June 19, 2018  
ET 18-0018

Subject: Docket No. 50-482: Supplement to License Amendment Request to Revise Technical Specifications to Transition to Westinghouse Core Design and Safety Analysis Including Adoption of Alternative Source Term

**Attachment I: Response to Request for Additional Information (Non-proprietary)  
(49 pages)**

**Figure 1: Flow path to the Control Room for FHA**

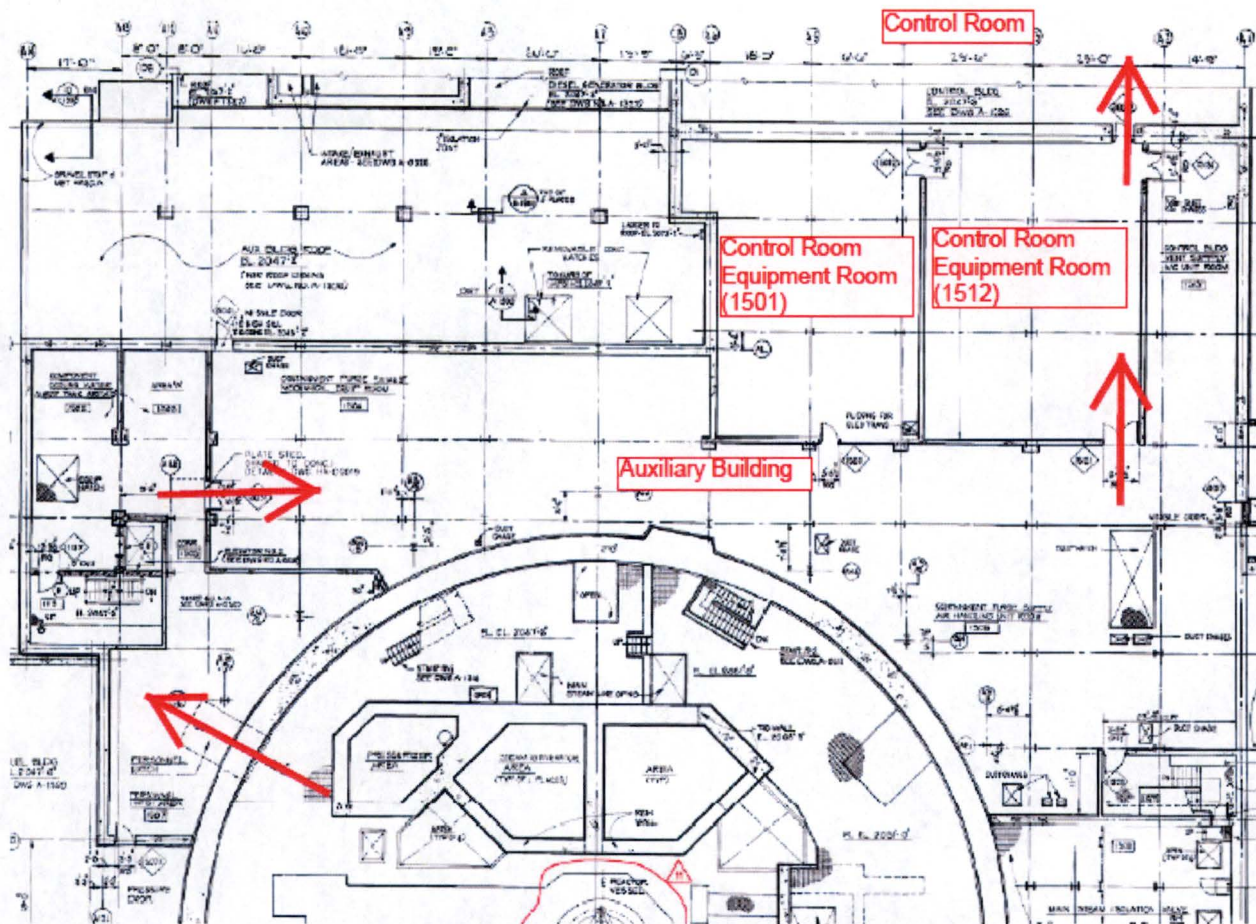
1. Please provide justification for the assumptions made regarding the flows assumed into the auxiliary building, the dilution volume credited for the auxiliary building and the unfiltered inleakage into the control room considering the possible environmental conditions due to winds entering the open containment penetrations or "stack effects" in the containment or revise the assumptions and provide a justification for the new assumptions. Please consider all the different configurations for containment openings allowed by your TSSs. Note that RG 1.183 allows mixing in other volumes such as the containment (up to 50% of the free volume) and the fuel building on a case-by-case basis, but no guidance exists for mixing in the auxiliary building.

Additionally, at the audit it was discussed that the FHA in containment with an open personnel airlock originally discussed in the acceptance review supplemental response (ET 17-0011) had conservatively simplified the control room model by not modeling the control room equipment room (subsequently referred to as the equipment room). In order to more accurately model the FHA in containment with an open personnel airlock, the analysis has been revised to include the equipment room. Therefore, in addition to providing the original information requested at the audit, additional discussions associated with how the equipment room was modeled are also included. The inclusion of the effects of the equipment room in the model resulted in a decrease in calculated doses. Margin obtained from the more accurate model has been utilized to ensure additional conservatism in the remaining input parameters.

The location of the containment, auxiliary building, equipment room, and control room to one another is shown in Figure 1. As shown in the figure, radionuclides that exit containment through the personnel hatch must first enter the auxiliary building. Next, in order to ultimately reach the control room, radioactivity needs to travel from the auxiliary building to the equipment room. Once inside the equipment room, radionuclides may either leak or be transferred (via the control room HVAC system) into the control room.

The equipment room is part of the Control Room Envelope (CRE) and is serviced by the control room HVAC equipment. As shown on Figure 1, each train of control room HVAC equipment has its own independent equipment room. If both equipment rooms are considered, it will result in a larger volume available for dilution of the radionuclides. Furthermore, Room 1512 will have greater inleakage into it (from the auxiliary building) and from it (into the control room). This is due to the fact that there are two doors that connect Room 1512 to the auxiliary building (as opposed to one door for Room 1501) and one door that connects Room 1512 to the control room (as opposed to no doors connecting Room 1501 to the control room). Thus, in order to conservatively minimize the equipment room volume only the more limiting equipment room, 1512, is modeled.

Regarding the unfiltered inleakage from the auxiliary building to the equipment room, as shown in Figure 1, there are two doors that connect the auxiliary building to the equipment room. In addition to these two doors, there are additional penetrations that pass through the wall that connects the rooms. Thus, all penetrations that unfiltered inleakage could pass through are considered.

Figure A-4(2)b of NAA-SR-10100 shows the leakage rate for metal doors with sound insulation as a function of pressure. As shown on the plot, at 0.11 in. of water pressure, the leakage rate is 16 cfm for a door that pressure tends to open and 12 cfm for a door that pressure tends to close. The methodology outlined in NAA-SR-10100 to scale the standard door was utilized for the two doors that connect the auxiliary building to the equipment room. Additionally, the overall leakage value for each door was doubled in order to account for the fact that the doors of interest are double doors. This conservative doubling accounts for the leakage through a portion of the door seals and doubles the contribution through corners, joints, and the lock jamb sections.<sup>3</sup> The resulting inleakage for the two doors is 39 cfm and 23 cfm at 0.11 in. of water pressure.

Next, for the unfiltered inleakage from the equipment room to the control room, as shown in Figure 1, one door connects the equipment room to the control room. In addition to the one door, there are also penetrations that connect the equipment room to the control room that are considered. Finally, the contribution of air leaking into the normal HVAC equipment is also addressed.

**Figure 3: Control Room and Control Building Ventilation Flows**

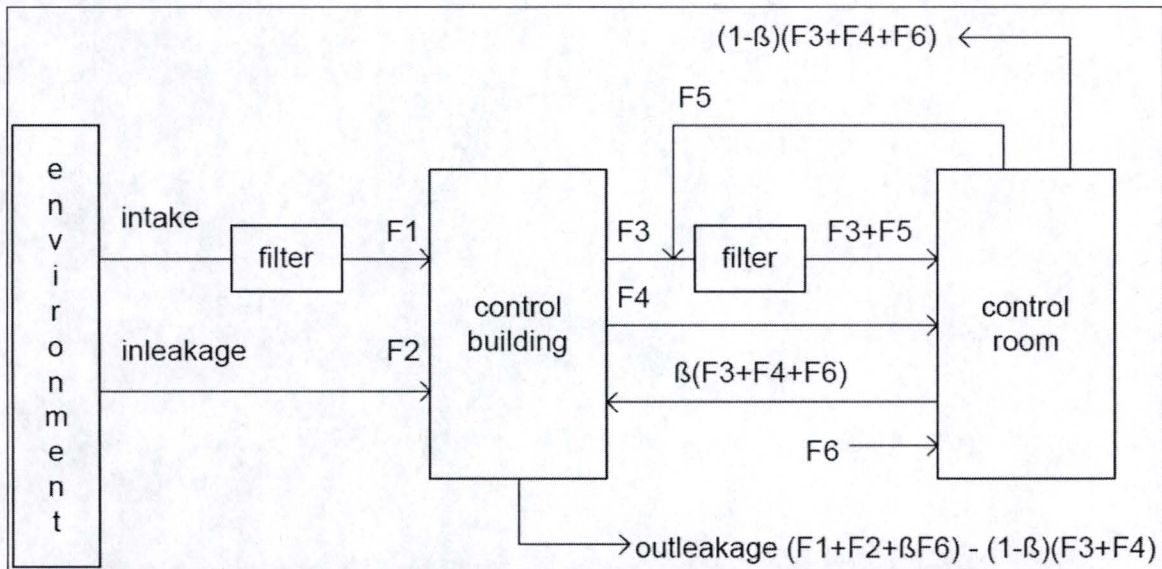
1. Please provide all inputs, assumptions and methods used for these calculations that were not previously provided. Also, the licensee is requested to include the inputs and outputs for the RADTRAD code for the staff's review.

The HVAC flows are illustrated in Figure 3 with flowrates described in Table 4:
